15B Failure Modes and Effects Analysis (FMEA)

The information in this appendix of the reference ABWR DCD, including all subsections, tables, and figures, is incorporated by reference with the following departures.

Figure 15B-1 Simplified CRD System Process Flow Diagram

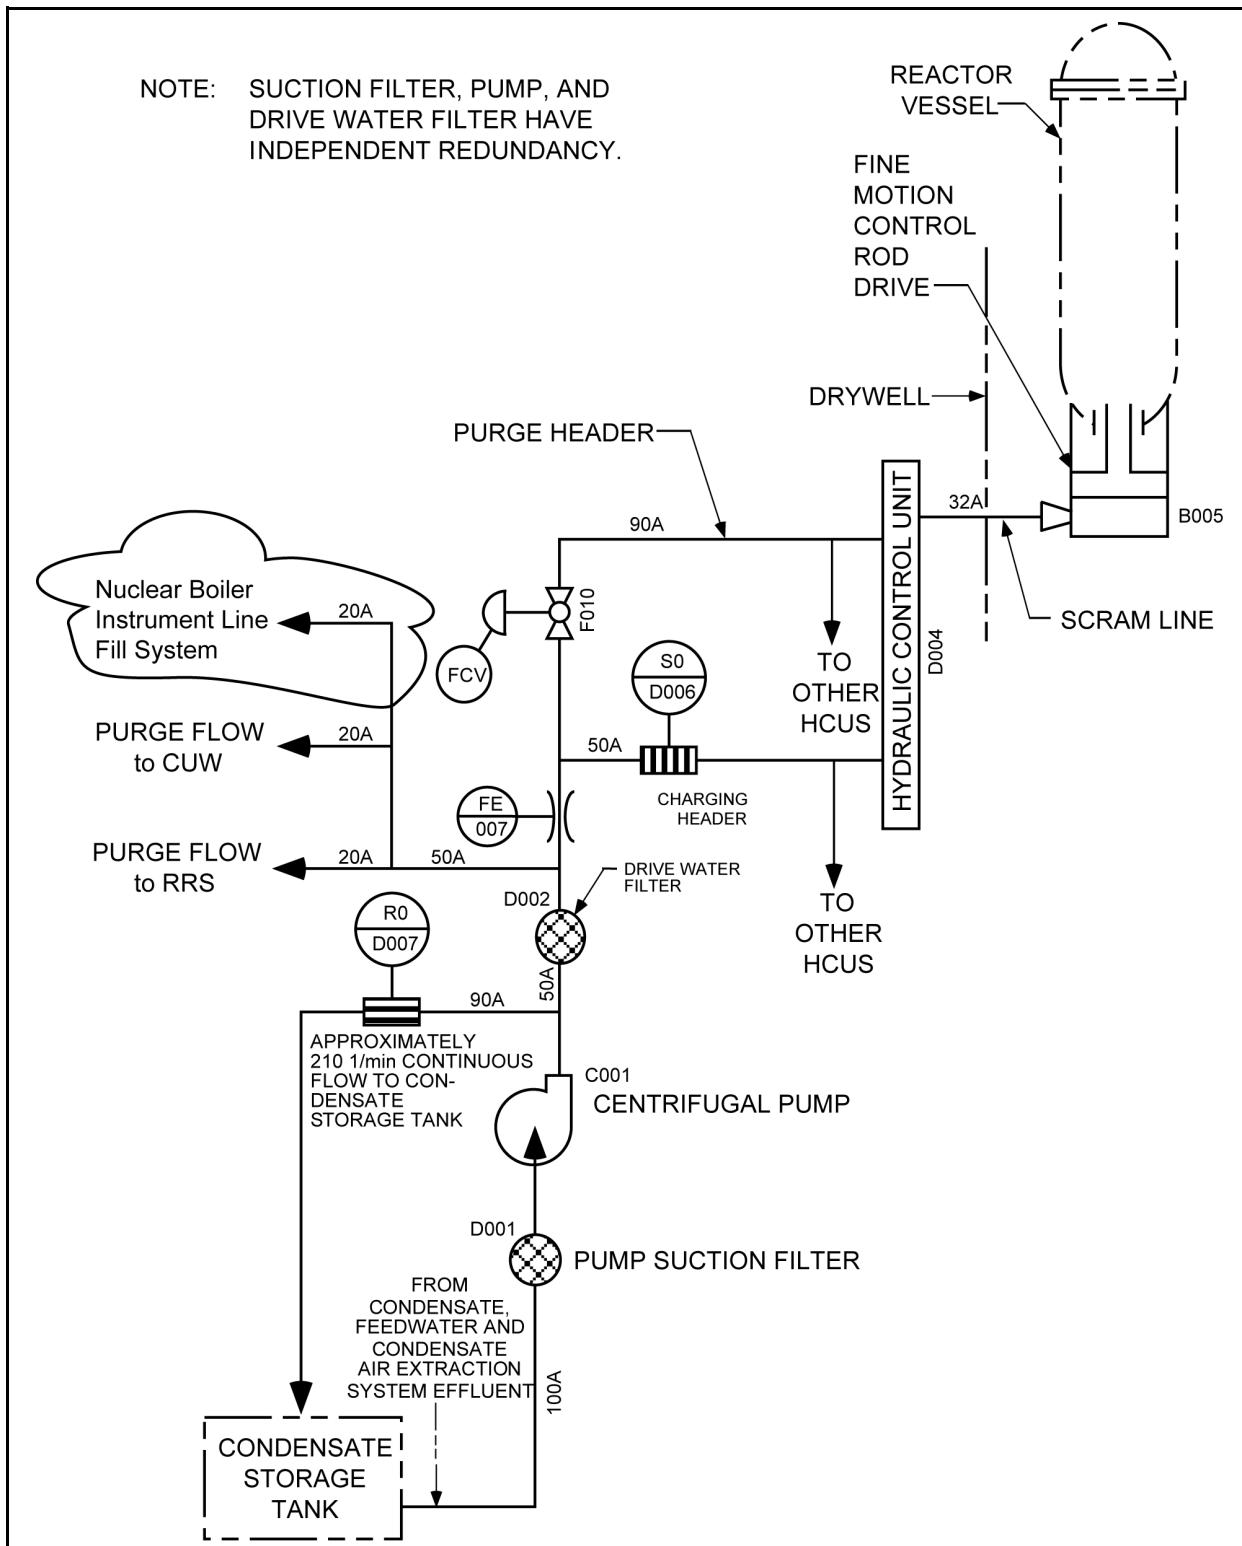
STD DEP 7.7-1 (Figure 15B-1)

STD DEP 7.7-1

A simplified CRD System process flow diagram is shown in Figure 15B-1. CRD System water is taken from the condensate, feedwater and condensate air extraction system, or Condensate Storage Tank (CST) through a suction filter by a centrifugal pump and discharged through a drive water filter to the HCUs. (During shutdown the CST is the primary source.) Each of these components is independently redundant and only one of each is in operation at any one time. A portion of the pump discharge flow is diverted through a minimum flow bypass line to the CST. The pumped water is directed to the HCU to provide hydraulic scram and to furnish purging to the drive. This system also provides purge water for the reactor internal pumps, nuclear boiler instrument lines, and the reactor water cleanup pumps.
